V2500-A5 SERIES PROPULSION SYSTEM NON-MODIFICATION SERVICE BULLETIN

This document transmits the Initial Issue of Service Bulletin EV2500-72-0495

NON – MODIFICATION – ENGINE – GEARBOX – SCAVENGE OIL FILTER HOUSING ASSEMBLY –
THERMOCOUPLE THREAD INSPECTION/REWORK

FIG. 1

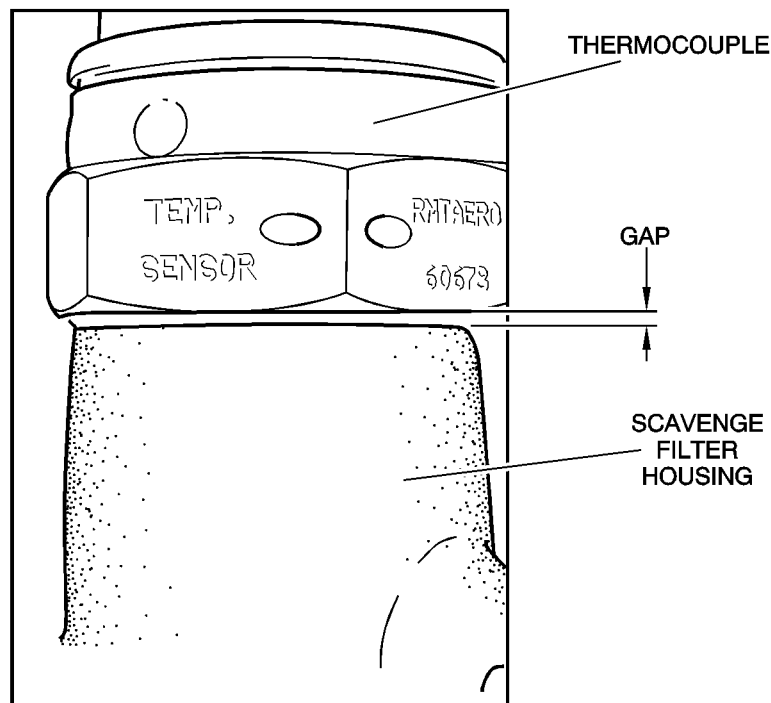
- (1) Visually inspect the oil temperature thermocouple / filter housing interface and check for any gap between the two faces using feeler gauges. If the gap is greater than 0,030 inch (0,762 mm) then proceed with rework instructions of part 3.B. If the gap is less than or equal to 0,030 inch (0,762 mm) no rework is needed. Refer to Fig.1.

- (3) Rework the internal screw thread on the oil scavenge filter housing for the oil scavenge thermocouple. The thread is 0.6250-18UNJF-3B and should have minimum axial length of 0,61 inch (15,5 mm). Carefully engage the screw tap in the thread and slowly turn the tap clockwise for 11 turns. Turn the screw tap counterclockwise to extract it. Be careful to avoid debris entering the oil scavenge filter housing.

- (8) Repeat part 3.A., inspection of the scavenge oil filter housing. If the gap is still greater than 0,030 inch (0,762 mm) remove the scavenge oil thermocouple per Engine Manual procedures (Ref. 72-00-60-050-006) and repeat steps 2 to 7, of the scavenge oil filter housing rework procedures, but turn the tap clockwise for 11.5 turns.
- (9) Re-install the scavenge oil filter housing assembly per Engine Manual procedures (Ref. 72-00-60-450-053).
